Good afternoon Chairman, Members of the Board My name is Guillermo Rueda, a District of Columbia architect for more than 30 years. My testimony as an expert in zoning and architecture is offered on behalf of Mary Lee and Deborah Hernandez whose properties on Albemarle Street adjoin and have use of the 16' pipestem that provides access to the applicant's tax lot at 3007.

The application proposes creating two theoretical lots with real problems: one, a larger lot [about 18,000 sf] is to be created [for a new house and pool] for the applicant's use that will be accessed by way of a new driveway from Appleton at the northwest corner of the lot where it meets 31<sup>st</sup> Street. This work [house one] is to be funded with the sale of a speculative second house of comparable footprint [83%] and height, but developed on half the buildable area on a lot 2. [About 9,000 sf, the pipestem represents about 10% of the total property.]

*Slide 2 Image: View of Development from Southeast*

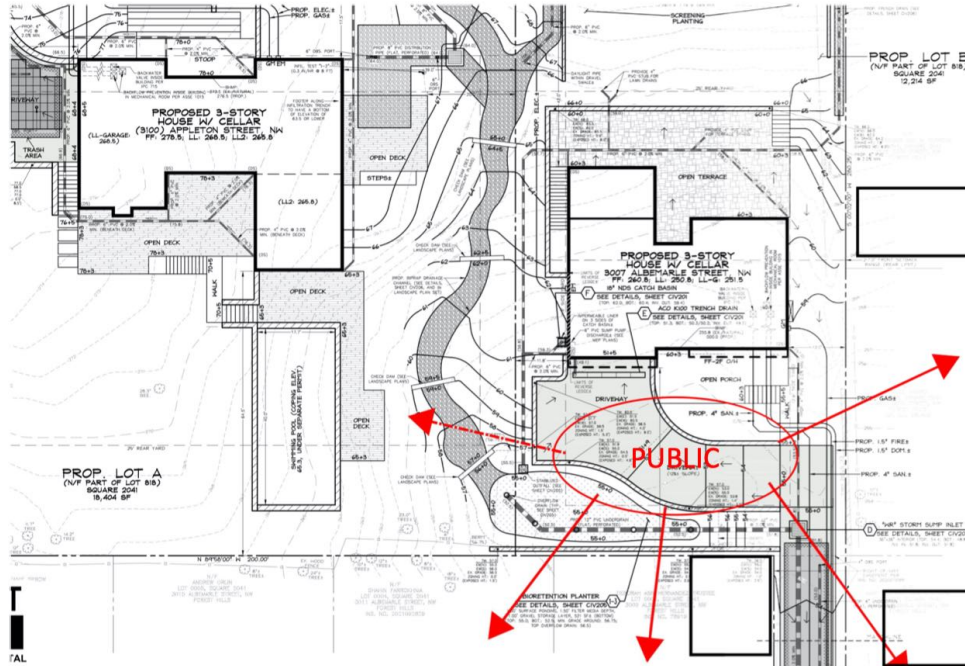
This first view captures how the proposed subdivision's addition of a second house directly behind 3009 and 3005 conflicts with R-8 zoning purpose and intent. The scale, volume and hardscapes at house 2 creates density that is incompatible

with R8 goals. In this case, placement of the second home at the bottom of the steeply sloped site is a direct result of the natural topography that the regulations seek to preserve. House 2 is proposed on the flatter terrain less than 50' from my clients' rear property lines with significant alteration required of the rear grade to provide an outdoor patio area cut into the hill.

Slide 3 image—Public Street shift to back of 3005 and 3009

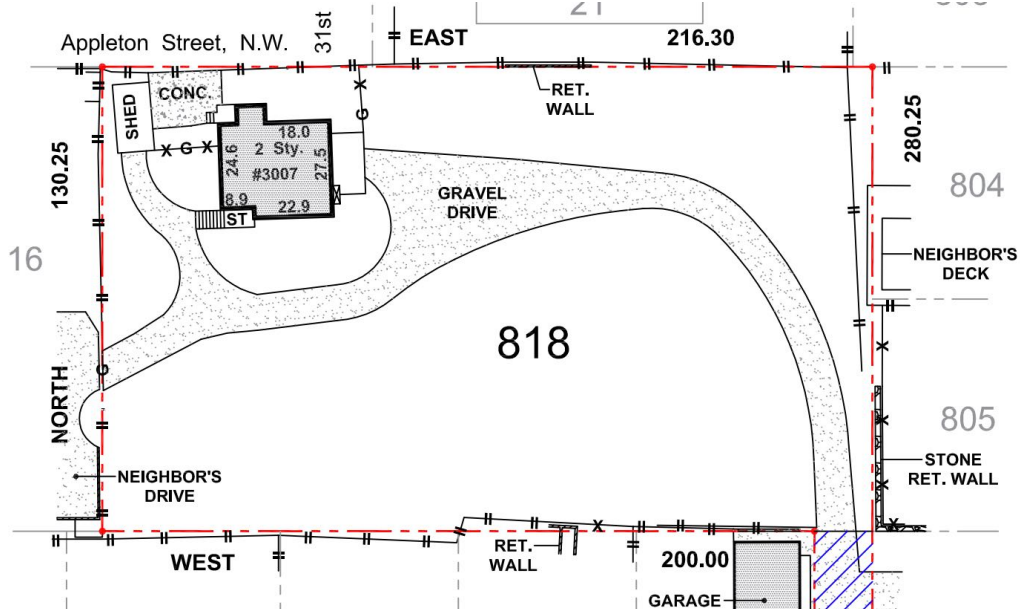
The site plan is marked up to show how public space by necessity will terminate more than 200 ft from Albemarle at the end of the pipestem and front yard of 3007—this newly created receiving space for 3007 is directly behind 3005 and 3009 and provides direct access and views to the back of no less than (5) different neighboring lots. This new setback means that 3005 and 3009 will have two public faces at the front and rear of their properties.

The House 2 project cannot rely on Special exception relief by theoretical subdivision because it cannot suitably meet the 24 ft access requirement of 305.3 (b). The 16' pipestem acts more like a street or alley and cannot be excluded as a driveway in this case as it is shared by three properties (3005, 3007 and 3009). Beyond the 3005 and 3009 garages, vehicular access onto 3007 would be limited to a 12' x 24' concrete pad next to a ramp down below grade to the basement level garage a big change from the current meandering 300 ft long drive. The grade change requires it be bound by site retaining walls and nowhere does the applicant show (as they report) where (4) zoning sized parking spaces can be located on lot 2—they don't fit. A small area on the drive ramp is shown for some chance of turnaround, but forget about delivery trucks or guests that will try to venture on-site to avoid the

250 ft. walk along the pipestem to house 2. There is no room to properly stack or turn around—especially if even one car is parked on the 14-15' driveway. Without room on site for cars, folks will necessarily walk between 3005 and 3009 and ensure further compromised privacy.

*Slide 4 Cross Section*

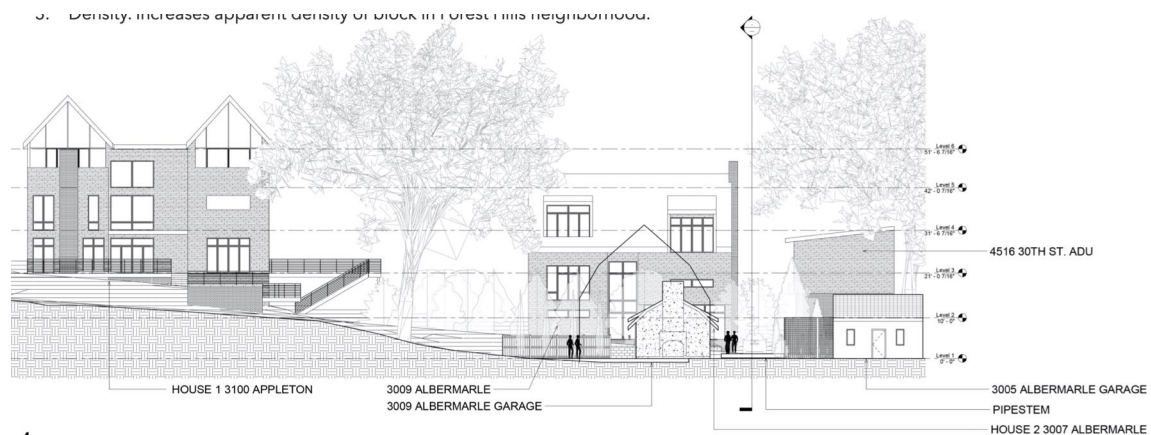
As I mentioned previously, the larger volume and scale of the proposed homes is adverse to the character of the neighborhood and near-by residences. Instead of the relying on the typical lower profile one and two-story homes in the immediate square and on Albemarle, the subdivision proposes 3 story schemes whose lower basement levels rise above the ground the maximum allowed (5 ft) so as not be considered an additional 4<sup>th</sup> floor. This creates a high vantage point look into the 3005 and 3009 properties.

*Slide 5 Longitudinal Section*

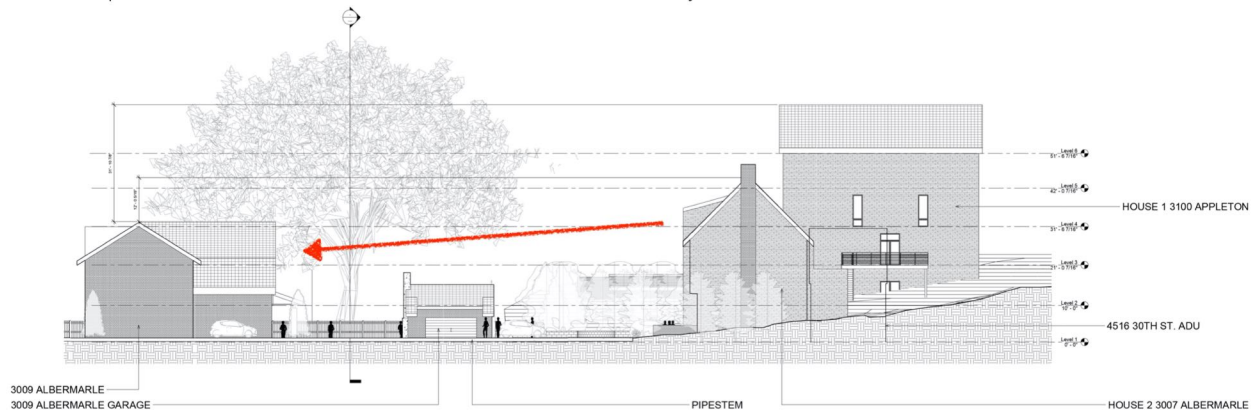
The longitudinal section shows how the slope influences locating the house closer to the rear property line of 3009 Albemarle. Additional site stress on the adjoining properties is created by the need to accommodate stormwater retention adjacent to the 3009 garage and also in the pipestem next to 3005 and 3009---well away from the 3007 house.

Furthermore, the height of House 2 when sited so close to rear line will negatively affect neighboring privacy. While trees are shown as possible screening at the 3009 property line, privacy concerns are not mitigated by the specified 12' high tree specimens even years later. This is evident even at the modelled height of 18 ft - there is little chance that the trees will provide privacy.

*Slide 8 Image - View from Pool*

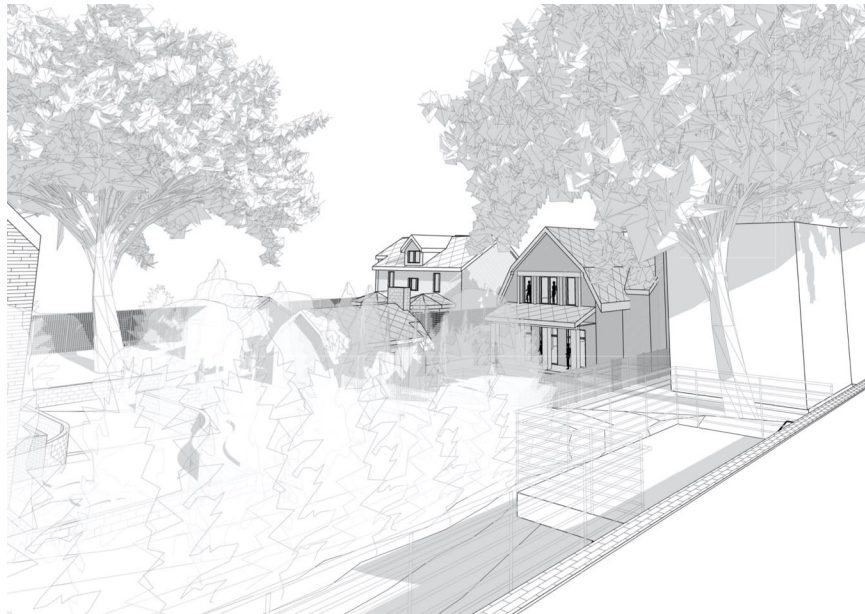
In conclusion, I offer this view this additional view from house 1's pool as it looks towards my clients' properties. The pool, located within 10 ft of the property line creates another vantage point above the neighboring properties.

The many cited measures and mitigating factors listed by the applicant to attempt to persuade this Board that a subdivision is possible are mainly reserved for

House 1. The actual solution provided for house 2 does not rise above the problems created by a lack of street frontage, narrow lot width and nonfunctional egress / ingress. The lot and principal dwelling that would be accessed from Albemarle are not only incompatible with the zoning plan but create insurmountable adverse affect on the neighbors.
